CITY OF ALBUQUERQUE

**RE: Juan Tabo Hills Estates
Manhole 47 Drainage Report
Stamp Date: 3/1/18
Hydrology File- M21D018; DRB# 1005278**

*Drop Manhole 47
Hydraulic Analysis*

Hydraulic Analysis of the Drop Manhole 47

JUAN TABO HILLS ESTATES STORM DRAIN DROP MANHOLE 47
EXISTING APPROVED DESIGN
EXHIBIT I

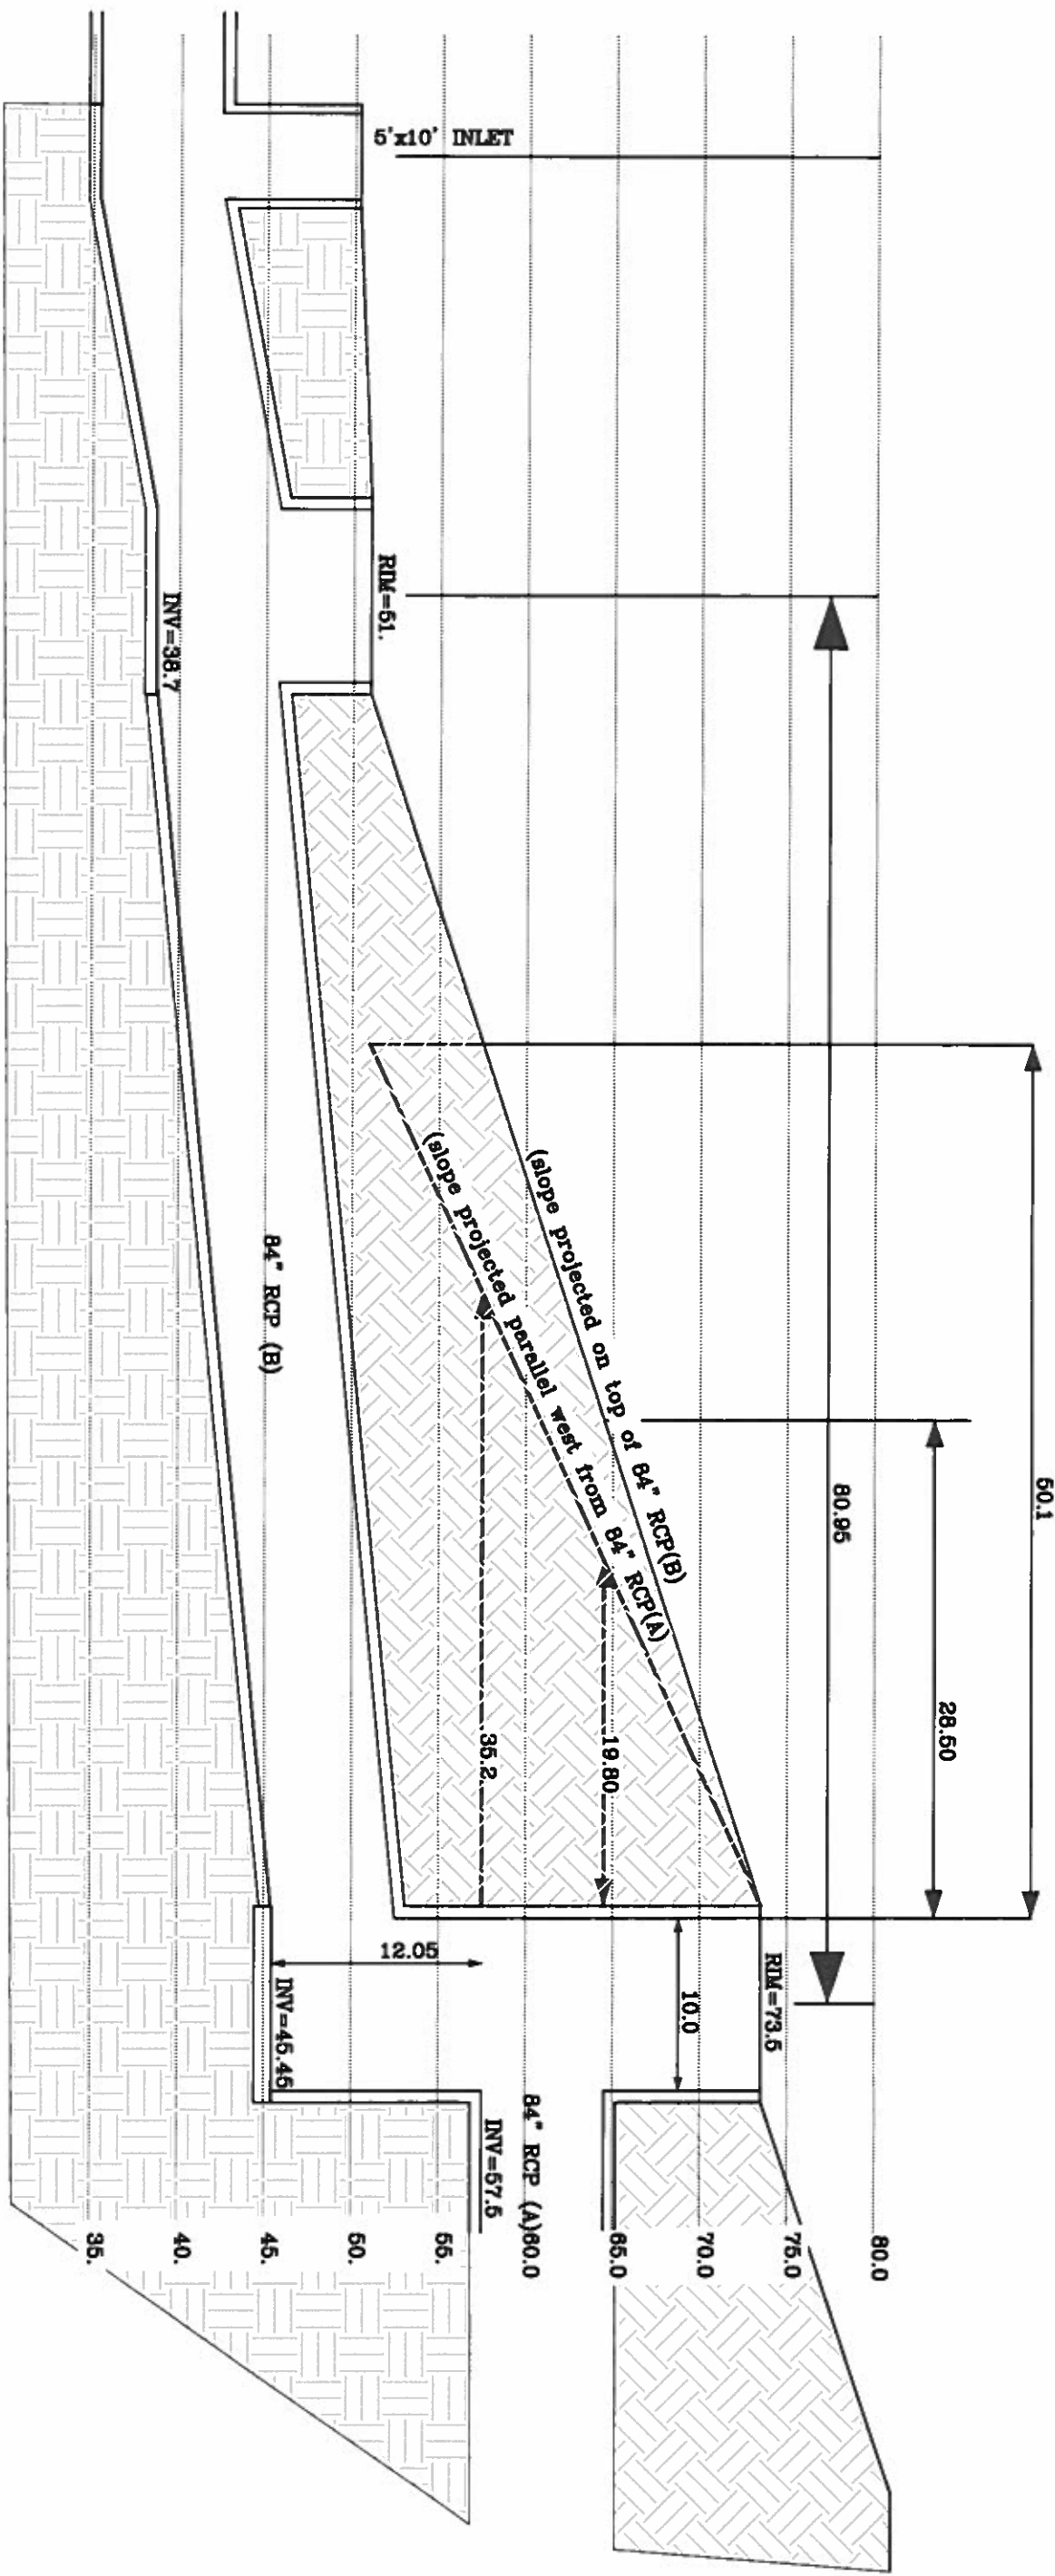
1. The proposal to re-align the inverts at Manhole 47 and maintain supercritical flow down the trunk to Tijeras Arroyo is unacceptable as the resulting hydraulic jump at the downstream junction box poses too great a hazard.
2. The proposed Energy Grade Line along the trunk under Sandia Sunset is too far above ground even for pressure manholes to be considered. Any unanticipated hydraulic jump along this trunk would be damaging to public and private property.
3. The excessive energy from the upstream storm drain will need to be dissipated at manhole 47. One option may be to lengthen manhole 47, creating a chamber long enough to force the R-2 flow regime as referenced in your report.
